METROPOLITAN GOVERNMENT OF NASHVILLE AND DAVIDSON COUNTY

STAFF RECOMMENDATION
1301 Woodland Street
September 18, 2013

Application: New construction—addition; Setback reduction
District: Lockeland Springs-East End Neighborhood Conservation Zoning Overlay
Council District: 06
Map and Parcel Number: 08309015200
Applicant: S. Mitchell Hodge, AIA
Project Lead: Melissa Baldock, melissa.baldock@nashville.gov

East façade – the bulk of the addition will be placed behind this gable.

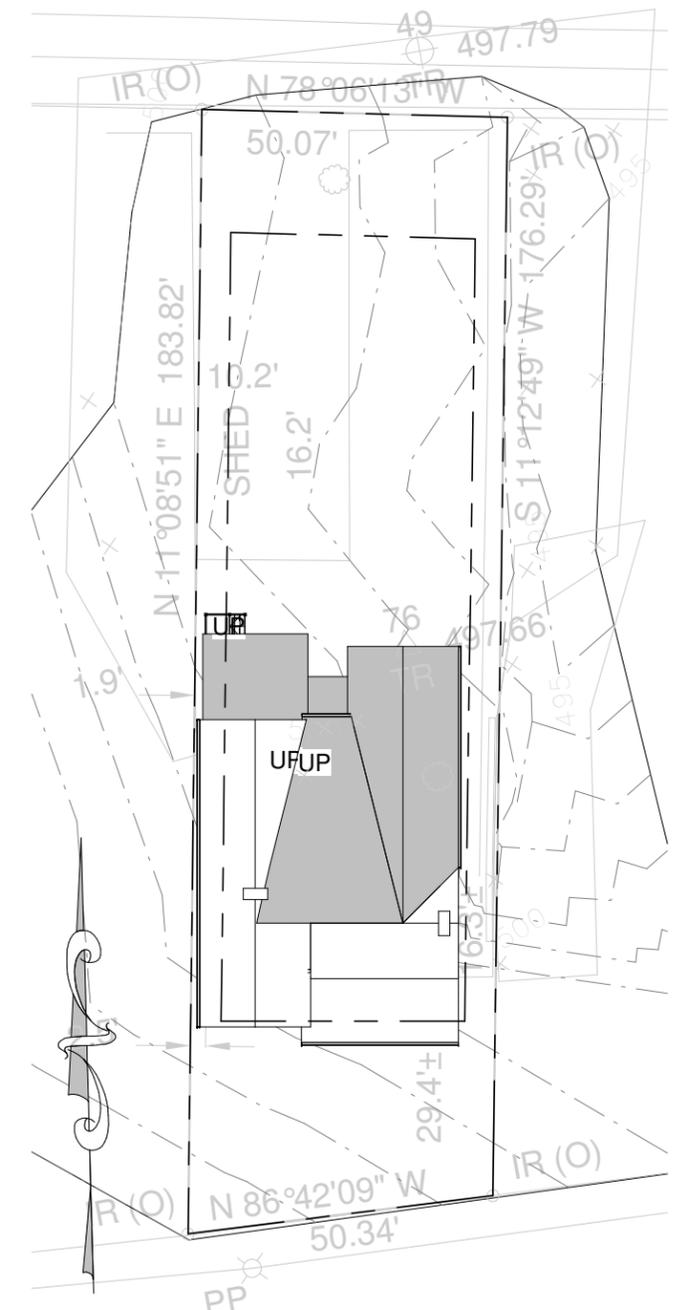
Height & Scale: The bulk of the addition will be built behind the eastern portion of the house. On the east façade, the addition will step in two feet (2') from the back wall of the historic house. After a depth of approximately eight feet (8'), the addition will step back out to match the line of the house. This side of the addition will have a maximum depth of approximately thirty-six feet (36'), but because of the house's gabled-ell form, it will only add approximately twelve feet (12') to the maximum depth of the house. This portion of the addition will have an eave height and a ridge height that matches that of the house, which is appropriate.

3 WEST ELEV.
SD-2 1/8" = 1'-0"

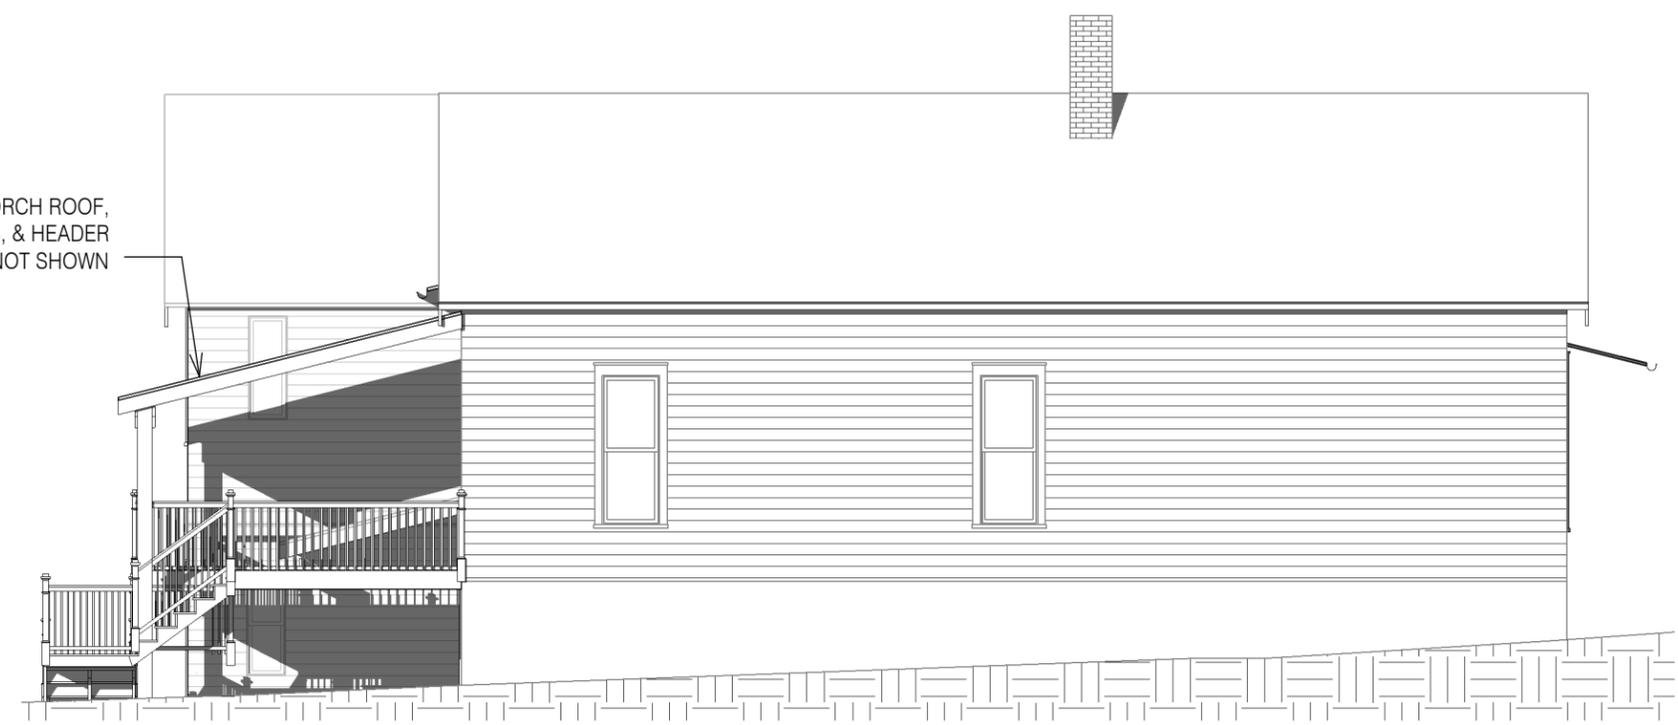
Location and Setback: The addition is located entirely behind the historic structure. The addition meets the base zoning requirements for setbacks on the east (right) and north (rear) sides. However, on the west (left) side, the addition does not meet the required five foot (5’) side setback. The addition will sit approximately one foot, ten inches (1’10”) from the side property line. The existing house also does not meet the base zoning requirements for setbacks on this side of the house. The addition will continue the line of the historic house, and will not be any wider than the existing house. The portion of the addition that does not meet the side setback is a covered, unenclosed deck that is approximately fourteen feet (14’) deep. Staff finds that the proposed side setback reduction is appropriate because the existing house does not meet this side setback requirement, and the addition will be no wider than the house. In addition, the portion of the addition that does not meet the setback is relatively shallow at just fourteen feet (14’) deep, and it is unenclosed. Therefore, the reduced setback’s impact will be minimized.

On the west façade, the addition is an unenclosed, covered deck that is approximately fourteen feet (14') deep and sixteen feet (16') wide. This covered deck does not step in from the back corner of the house, which staff finds to be appropriate in this instance since the deck is unenclosed and is relatively shallow at only fourteen feet (14'). The back wall of the house will not be removed with the addition of the covered deck. In addition, the deck's shed roof ties into the house at the level of the eave, making it significantly shorter than the house. All of these factors clearly distinguish the covered deck as an addition.
